Design Review Committee Meeting

5.I. Justin Honore 244 Mount Zion Road - New SF Dwelling

**DEPARTMENT OF PLANNING AND ZONING
PLANNER'S REPORT**

DATE: December 21, 2020
TO: Tonya Hutson
FROM: Lynn Patterson
RE: **Design Review – 244 Mt Zion Rd**

SITE PLAN PAGE 1 OF 2 PREPARED FOR:
244 Mount Zion
Rd SW

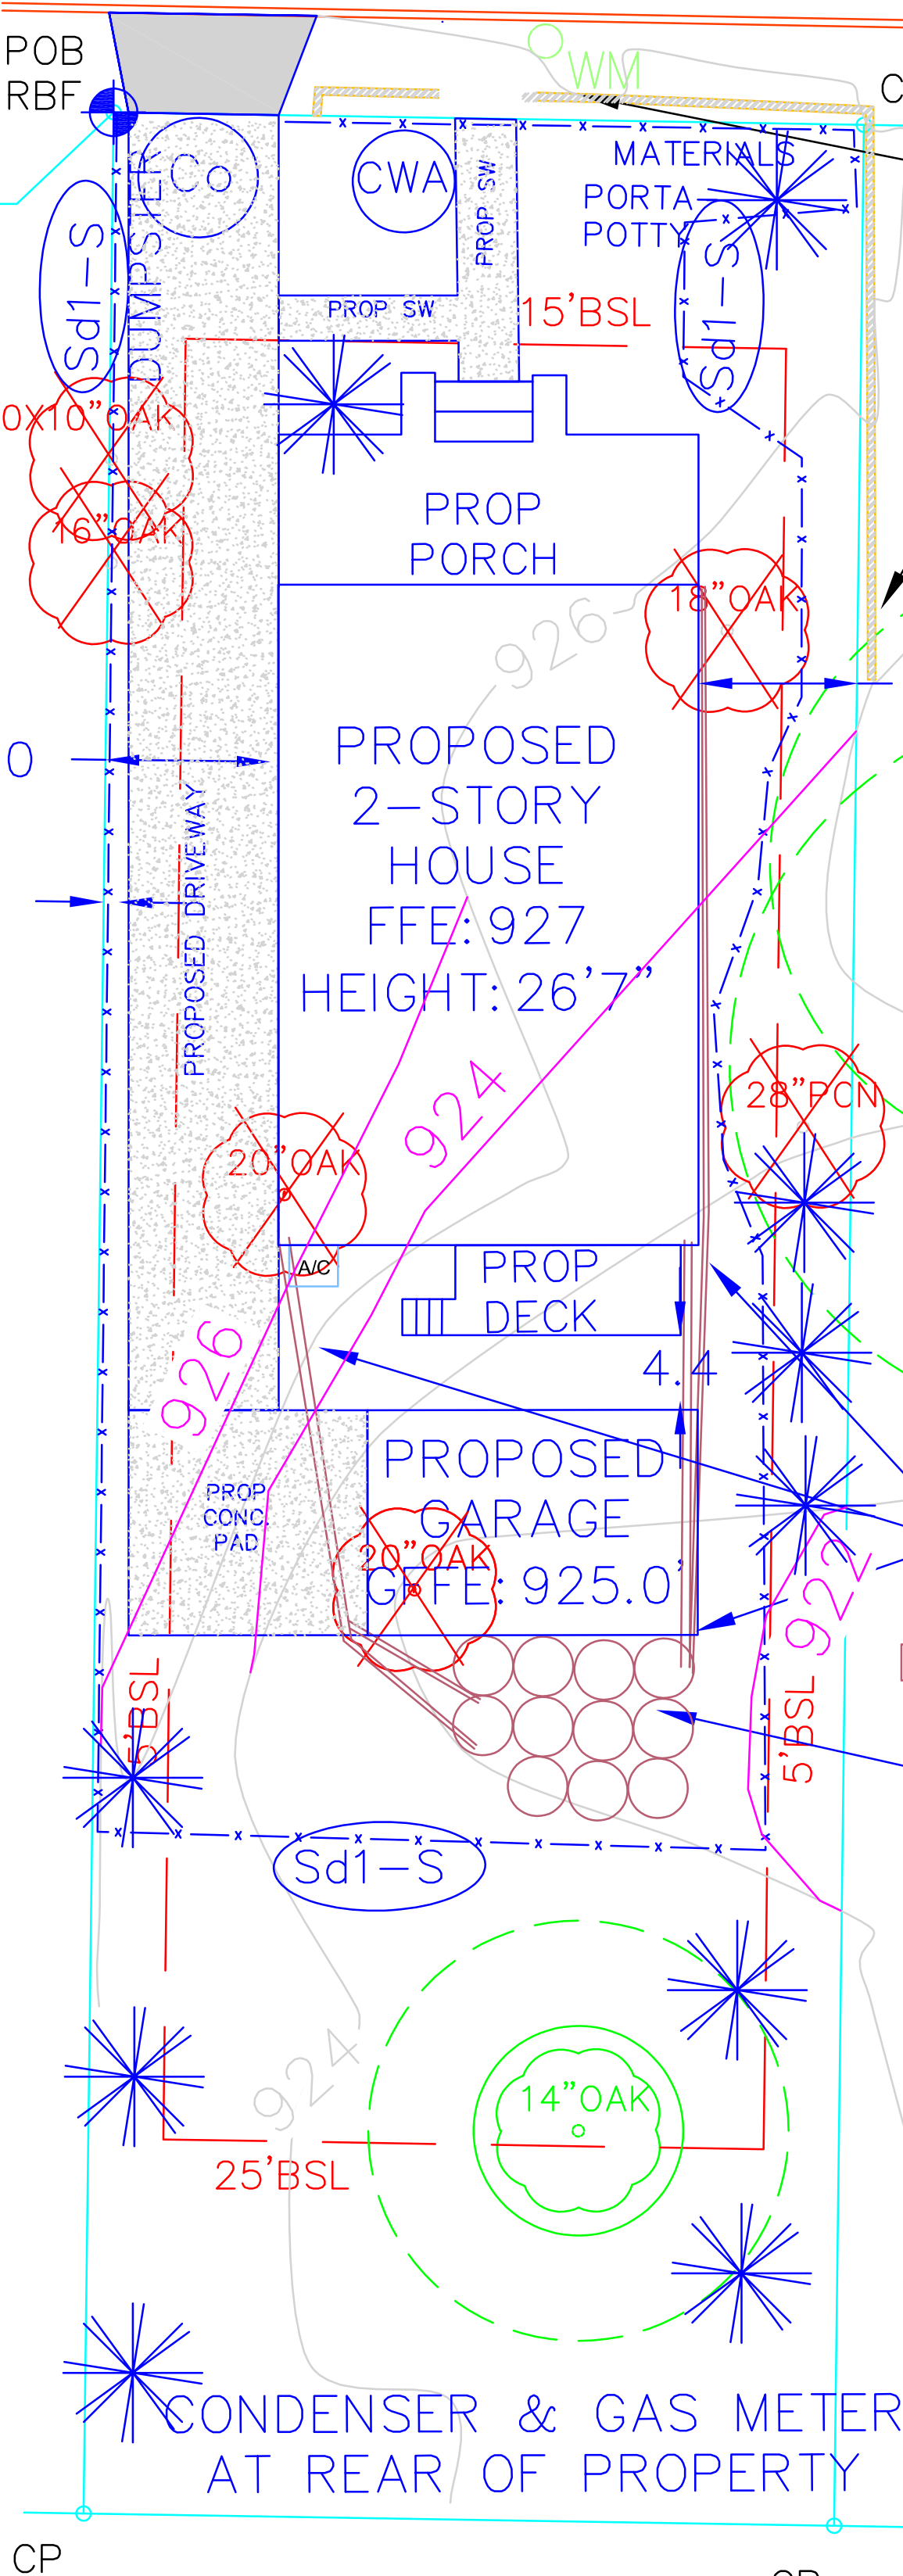
STAFF COMMENT: Existing retaining wall height not provided.

- **Provide existing retaining wall height.**
- **Window sill elevations is 2' and required to be 2 .5'. Design exception required.**

Hayes Plan
244 Mt Zion Rd
Elevations

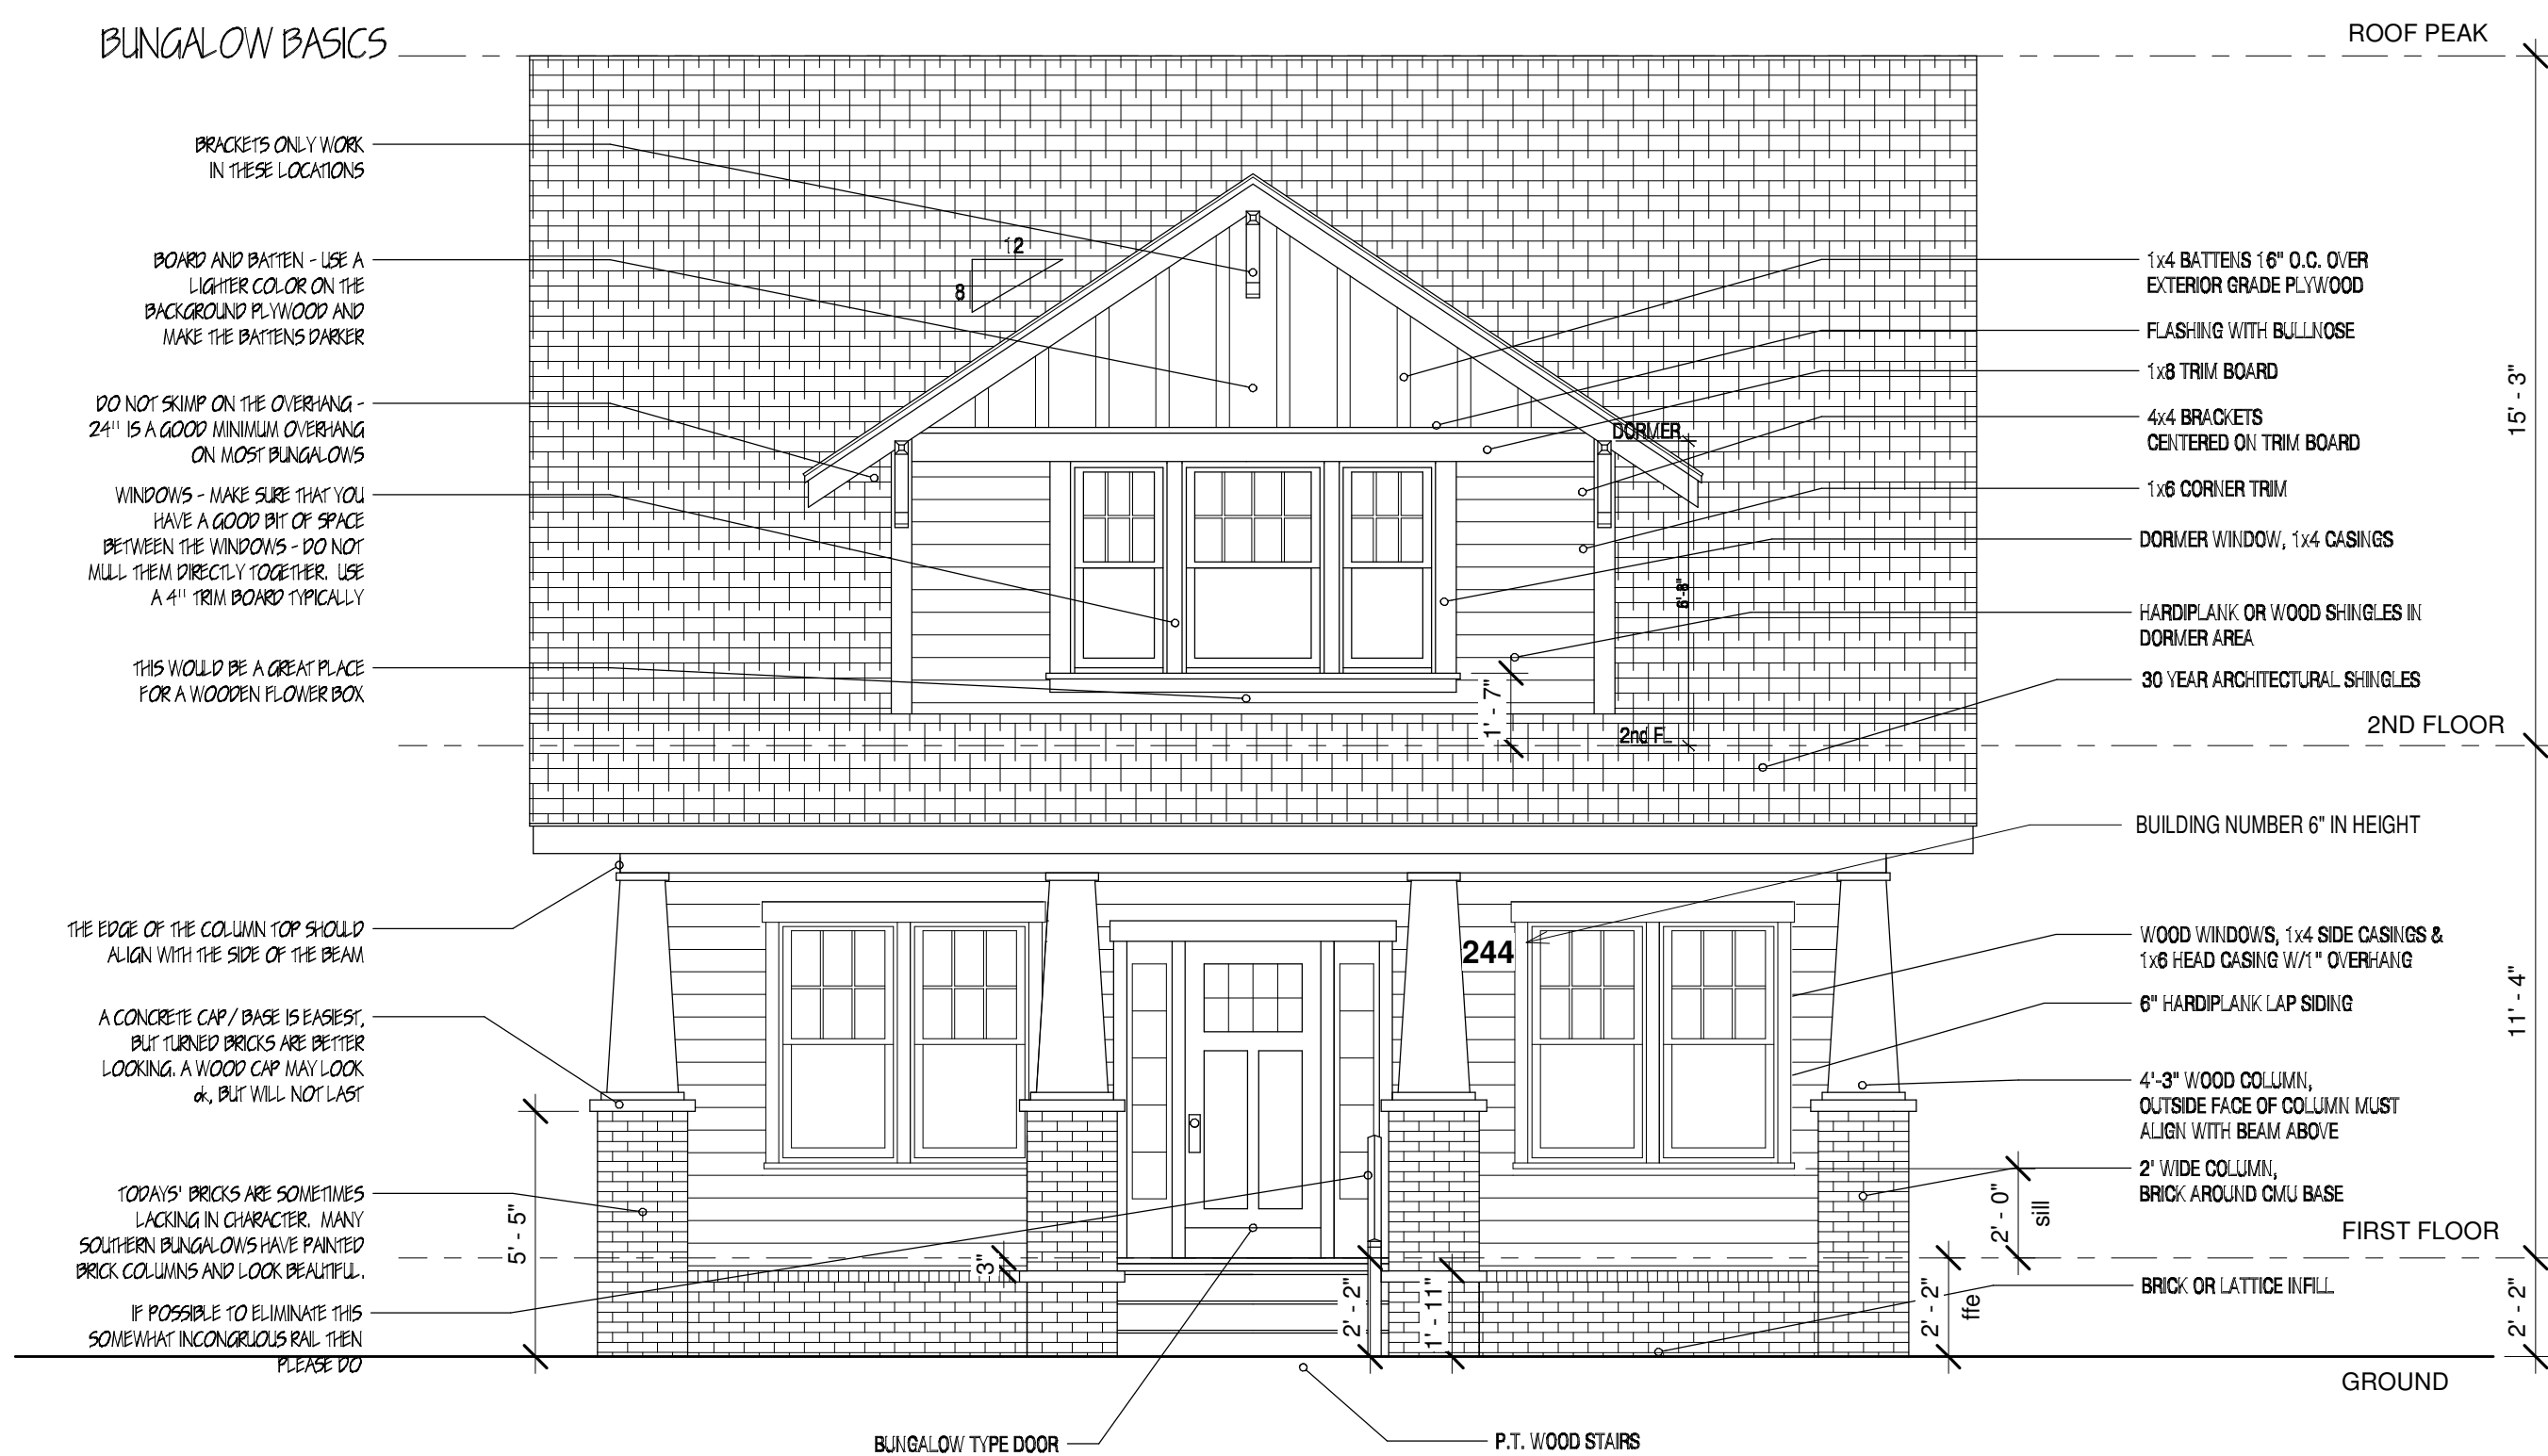
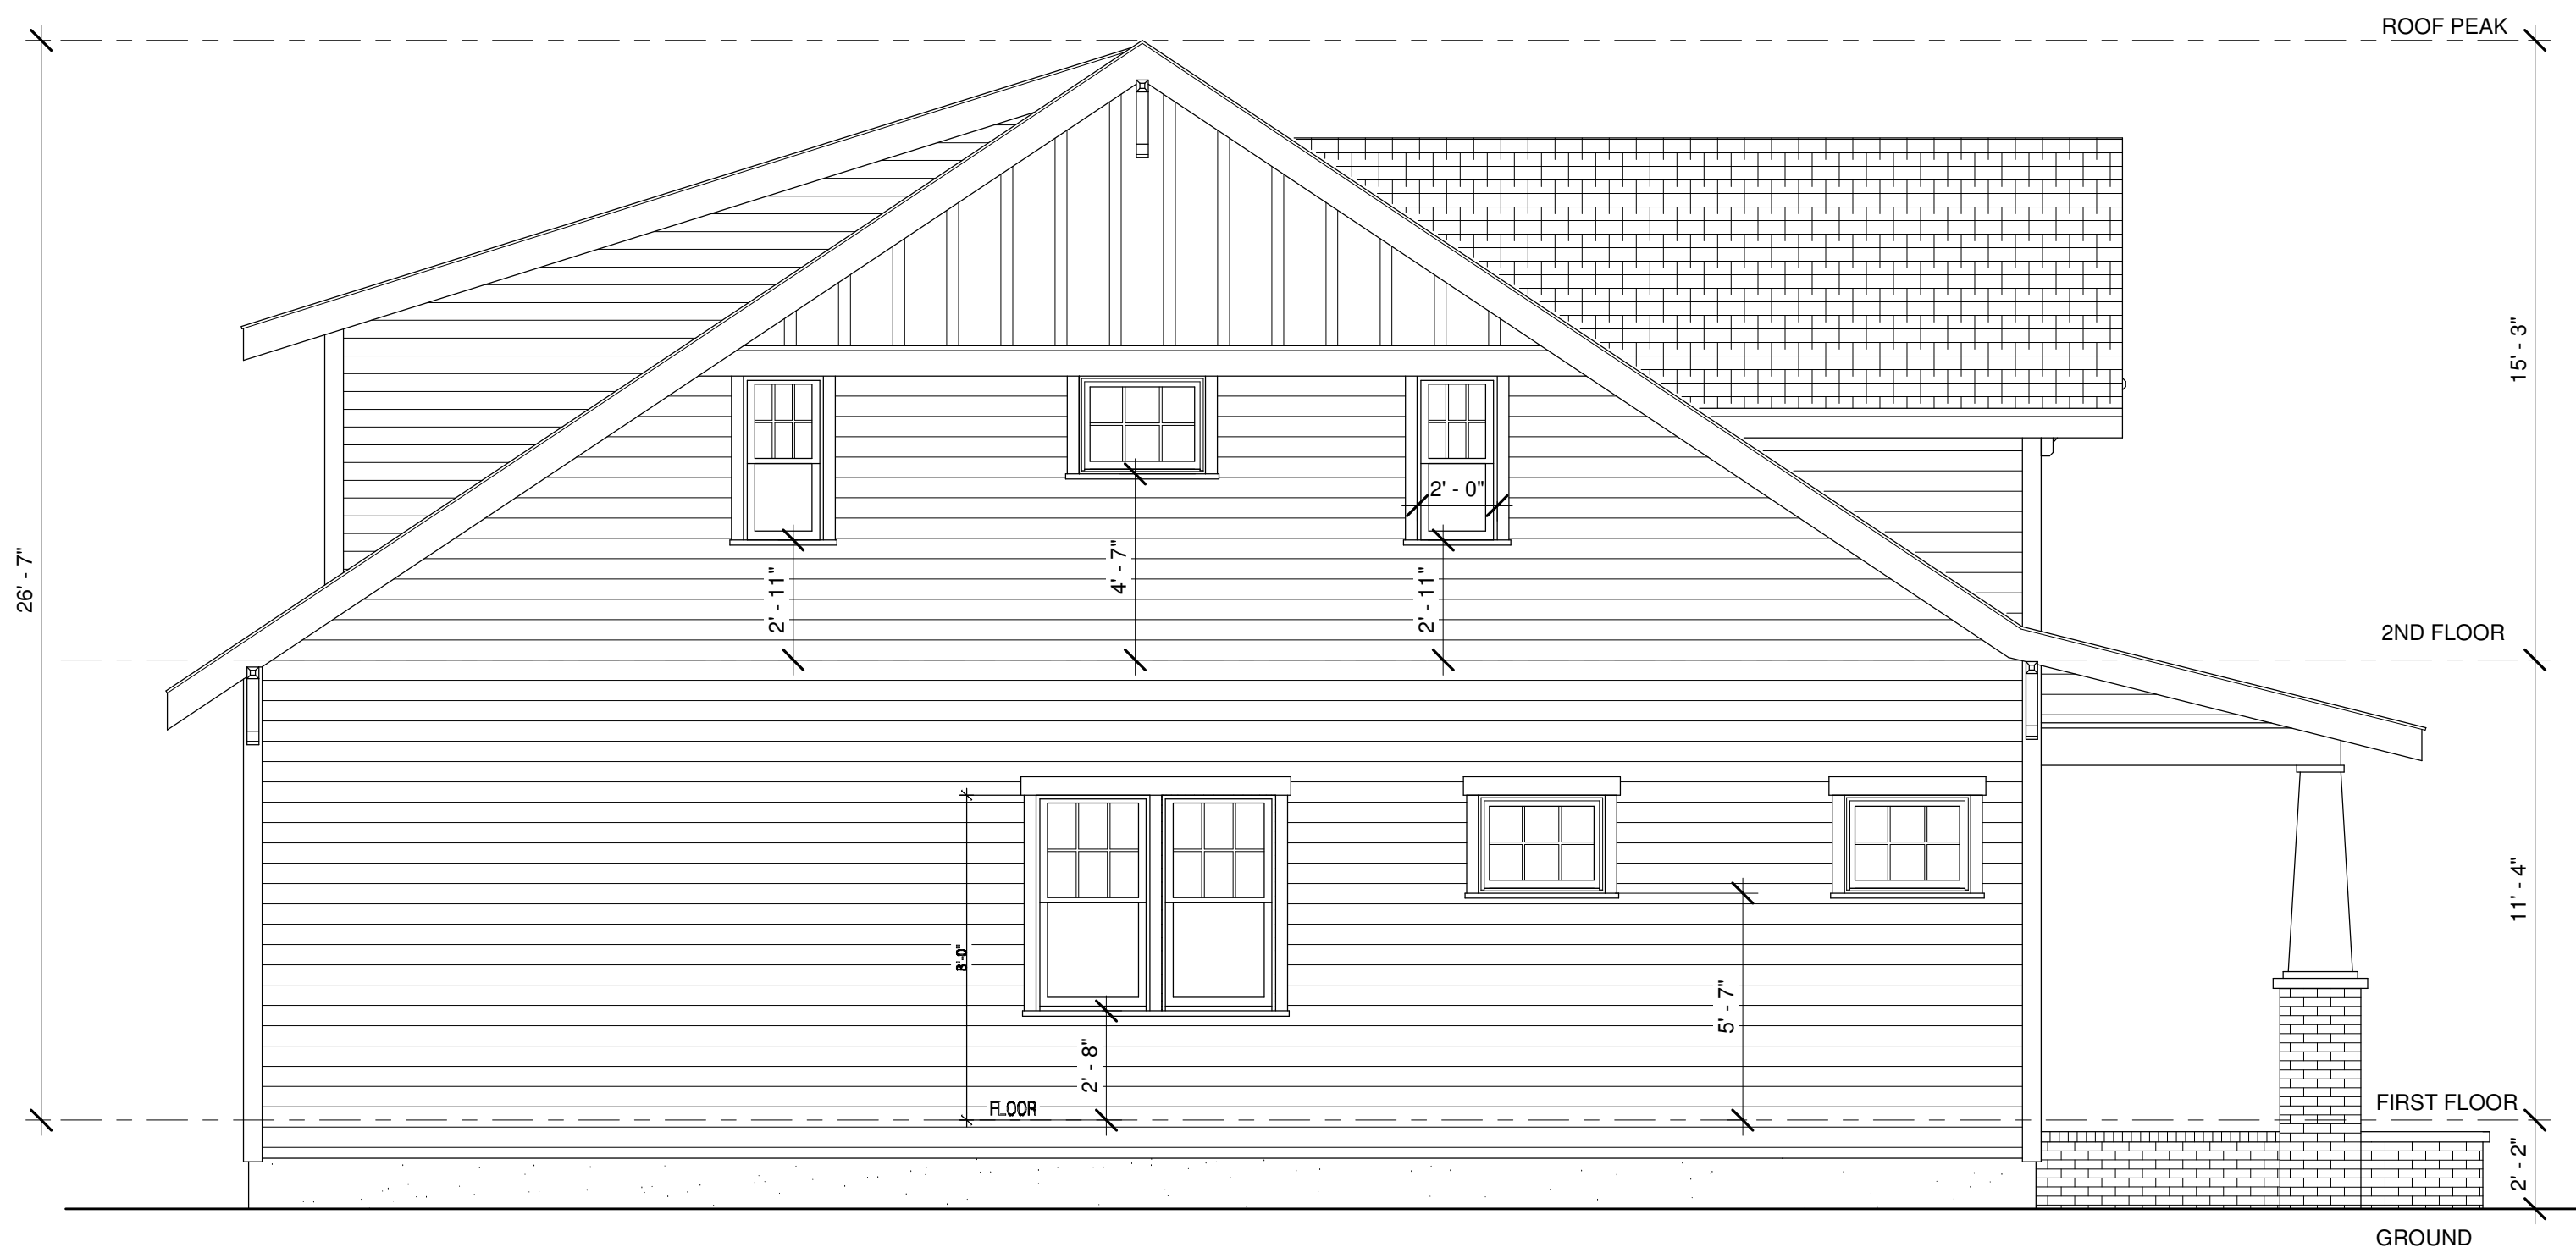
Sill height shown as 2'

- ✗ *Window Sills.* Enfronting first story window sills should be no less than two and one-half feet and no more than three and one-half feet above finished floor elevation.

Other: Sill height is 2' above ffe.
